AMENDMENT NO. 0001 TO ADVERTISED RFP DACW31-03-R-0008
EFFECTIVE: APRIL 23, 2003

LUKE C. MOORE ACADEMY HIGH SCHOOL

SHEET: C-4

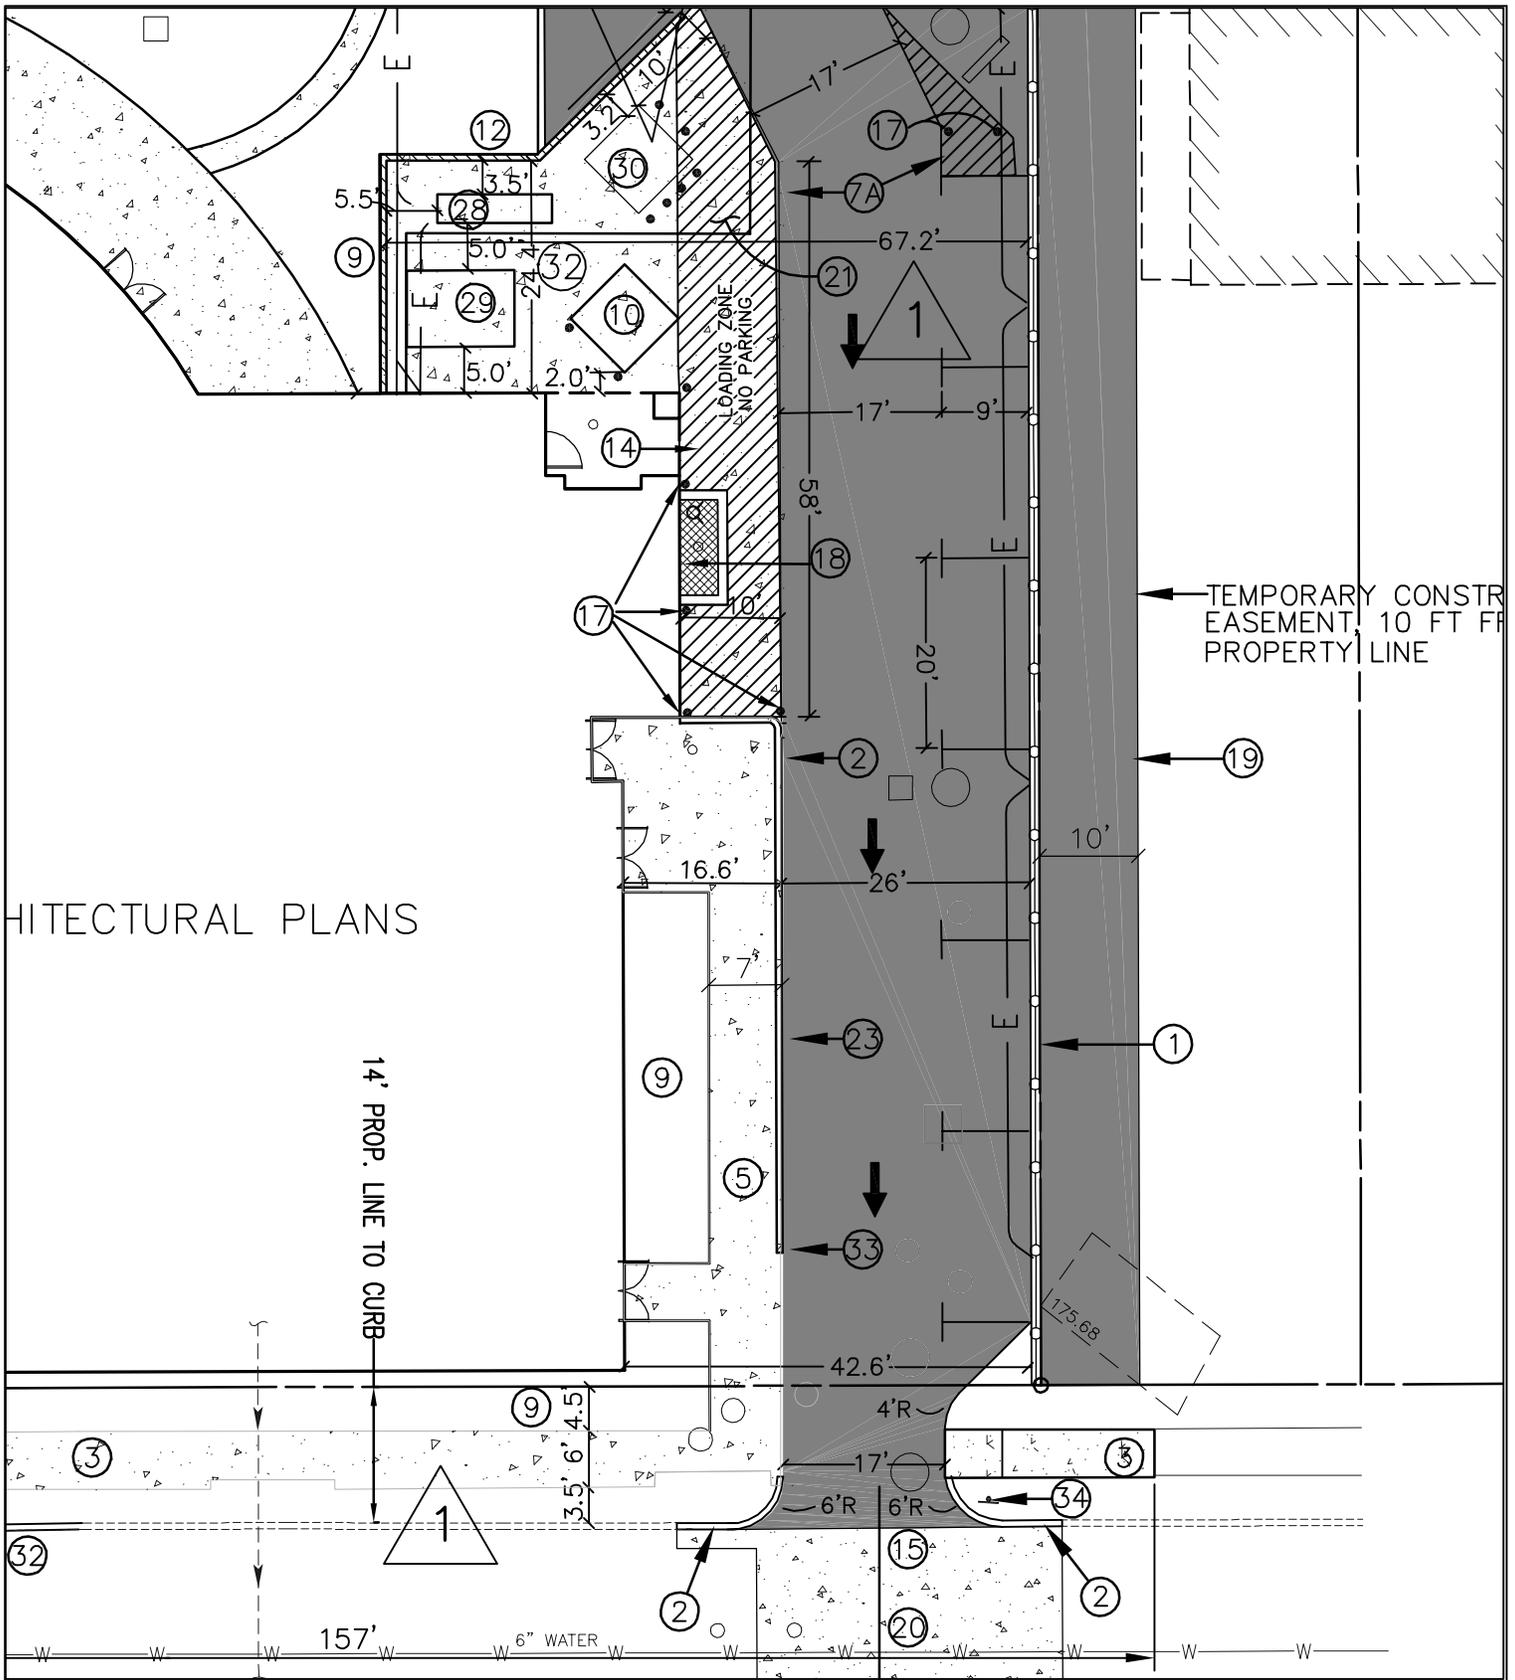
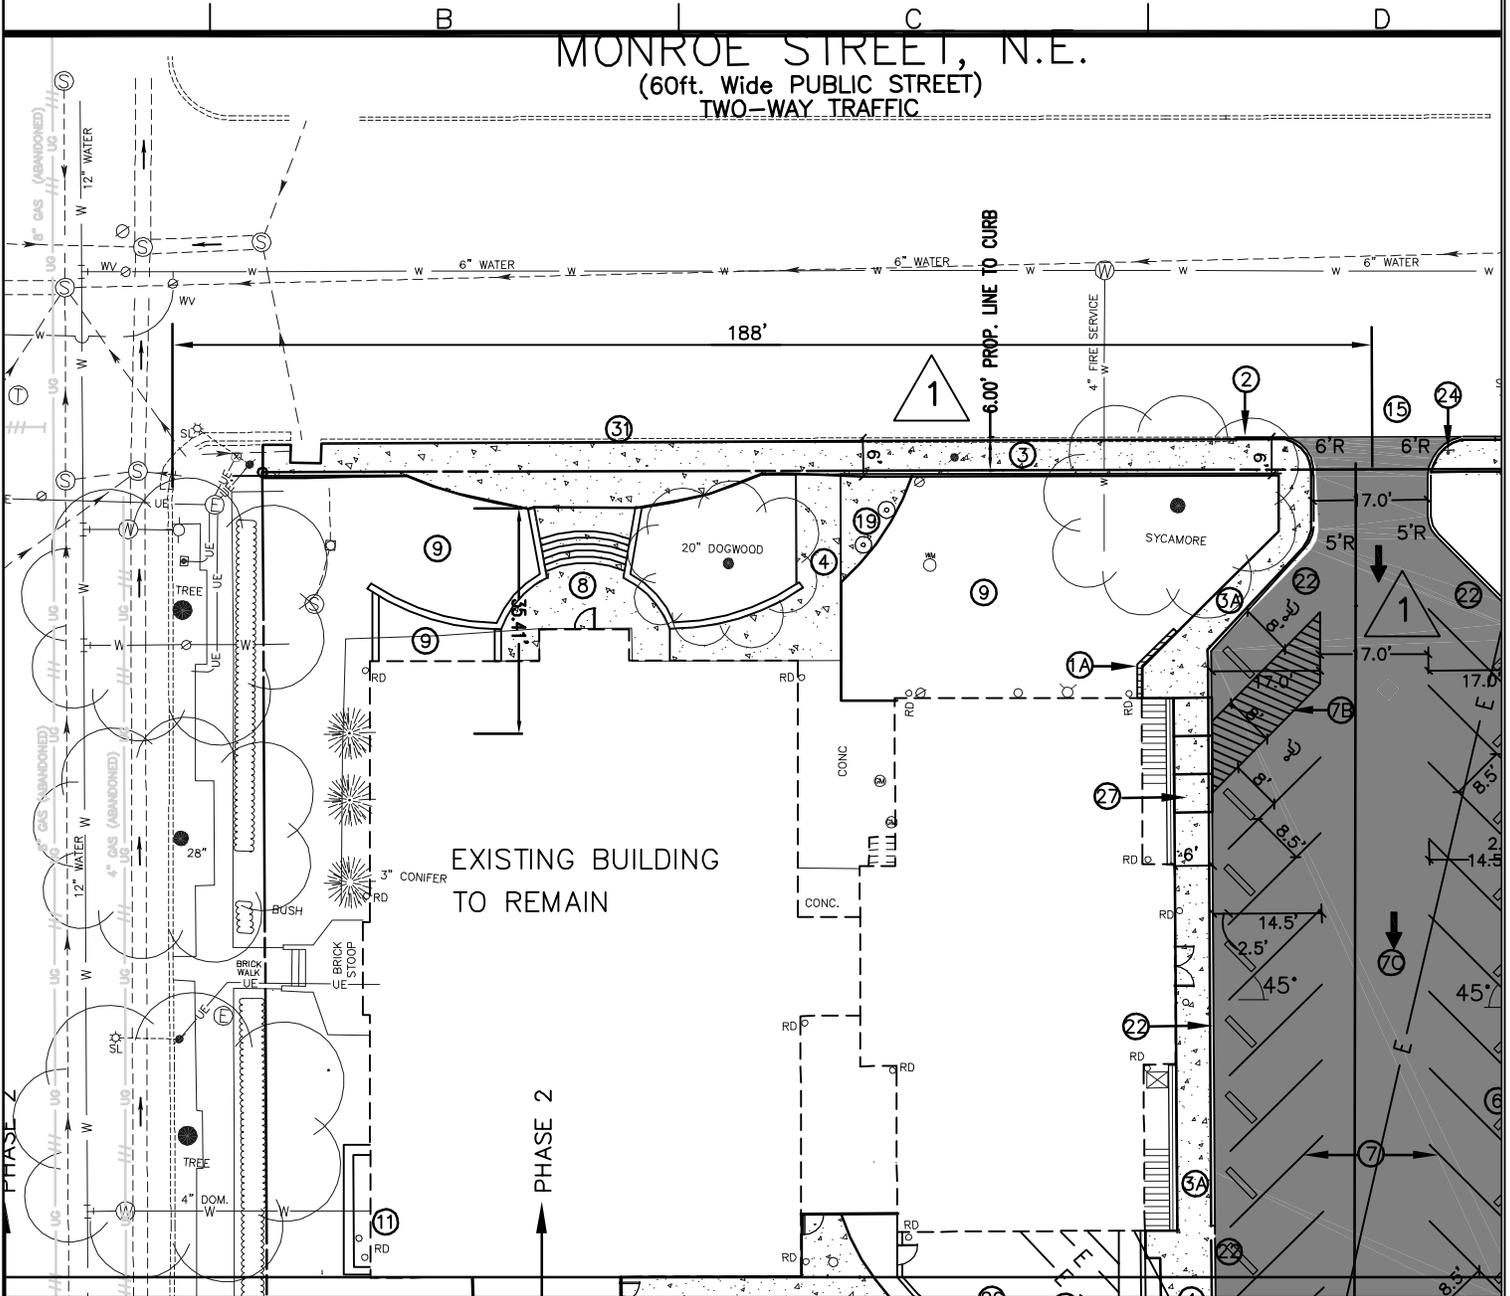
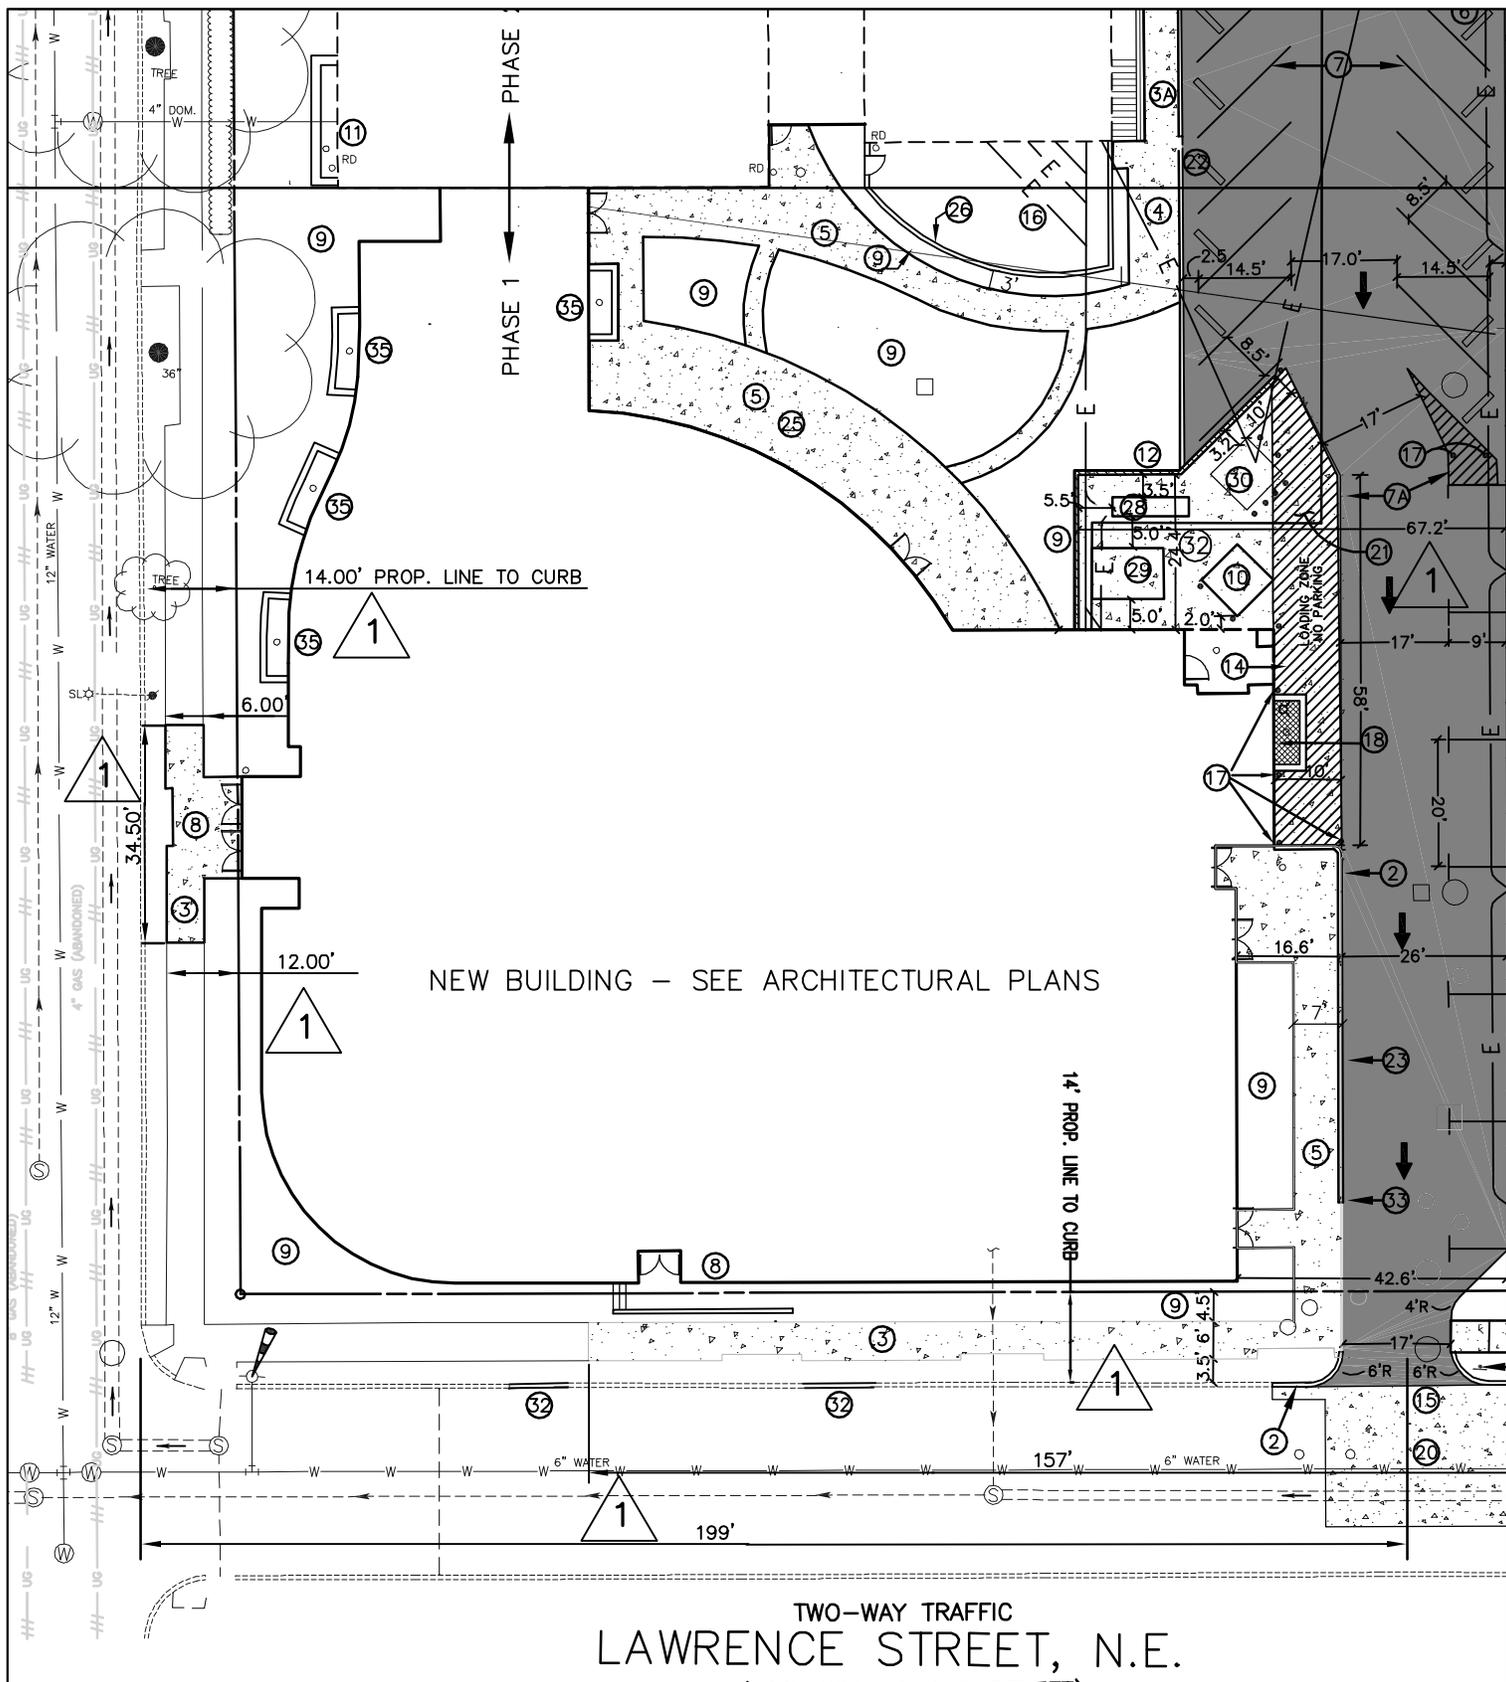
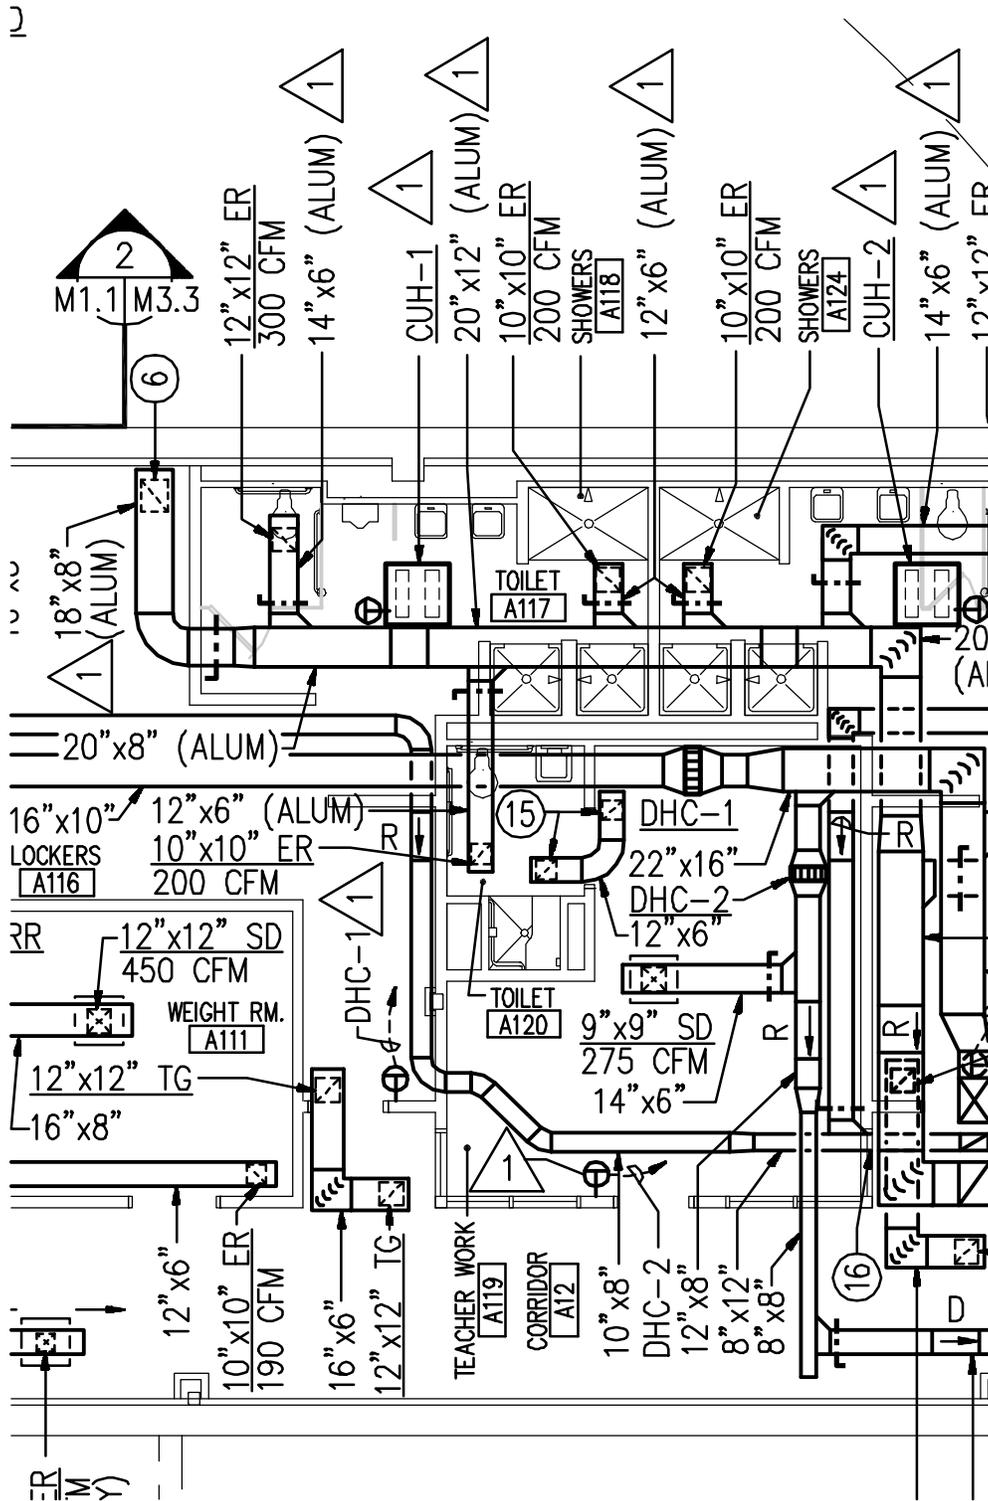
- Modify driveway width from 16' to 17' and modify associated dimensions as shown on attached drawings SK-C-1 and SK-C-2, dated 4/17/03.
 - Change Key Legend #35 text from "Additive Bid Item" to "Optional Bid Item".

- Add dimensions to the sidewalk area along Monroe St., Lawrence St., and 10th St as shown on attached drawings SK-C-3 and SK-C-4, dated 4/17/03.
- 57) Sheet LA-1:

SHEET: M1.1

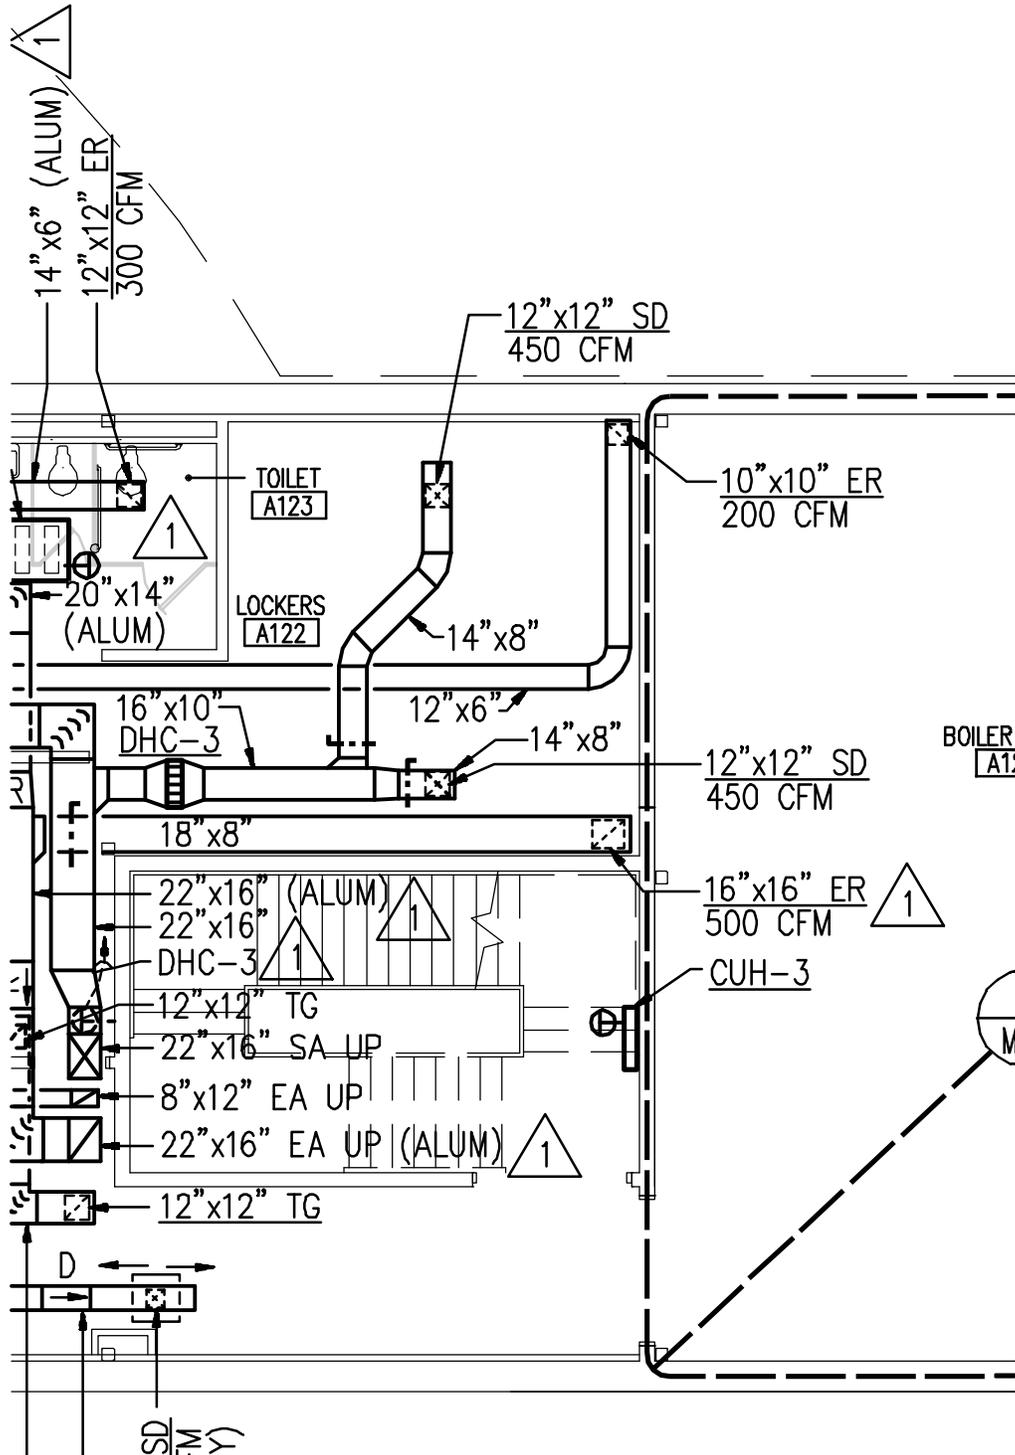
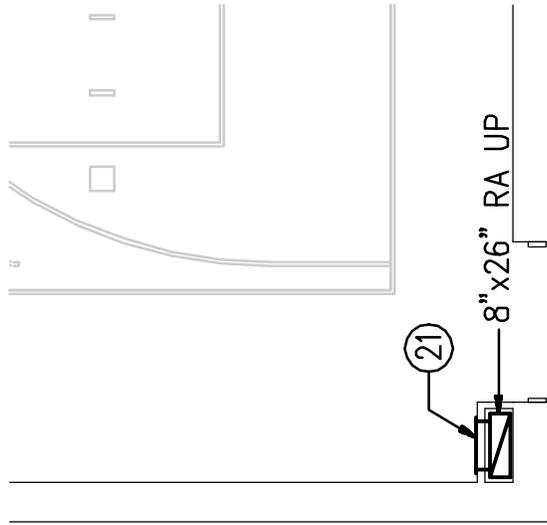
- 93) Sheet M1.1: Revise Sheet M1.1 in accordance with the attached sketches SK-M-1, SK-M-2, and SK-M-3 dated 4/17/03.
- 94) Sheet M1.3: Revise Sheet M1.3 in accordance with the attached sketch SK-M-4 dated 4/17/03.
